PRODUCT SERVICE BULLETIN

Bulletin Number: FB 2021-01

SUBJECT: Firebird V1R1 EVO Harness container systems with adjustable Main Lift Web

STATUS: MANDATORY INSPECTION BEFORE NEXT JUMP

DAMAGES

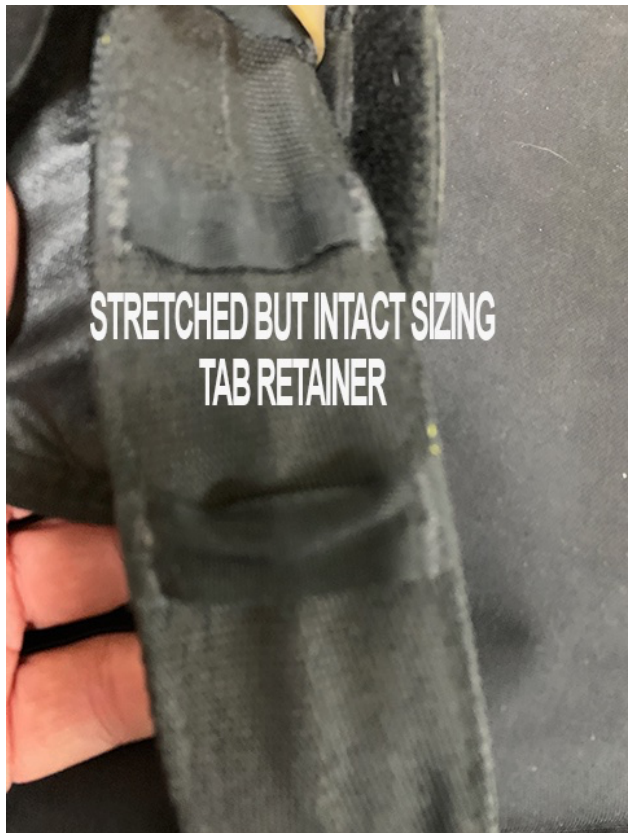
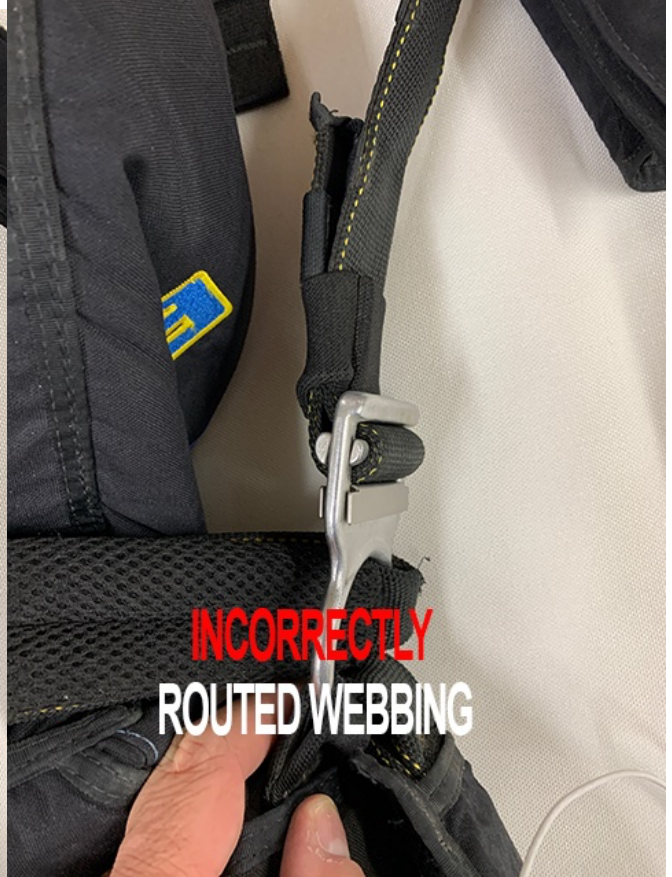
Right Main lift web undone, sizing safety tab ripped off and stuck under a stretched but intact sizing tab retainer (1/2" type 1), 555-2 ring installed **correctly**, **missing** spring, **NO** damage to type 4 stopper.

Left Main lift web threaded **incorrectly** (double routing, wrong direction, see pics), sizing safety tab attached with only a few stitches (69tex/E thread) ripped, sizing tab retainer stretched but intact, 552-2 ring installed **correctly**, spring present, **NO** damage to type 4 stopper.

In this incident, it appears that, the only thing that kept the webbing from coming undone, was the engaged sizing safety tab in the type 1 sizing tab retainer and that it subsequently broke under the load of the opening as **zero** damage to any other component occurred.

The right main lift web of the affected container that came undone does **not** show any damage on the type 4 stopper with only the sizing safety tab torn off and matches only the findings of at least one configuration of those simulations carried out by Firebird.
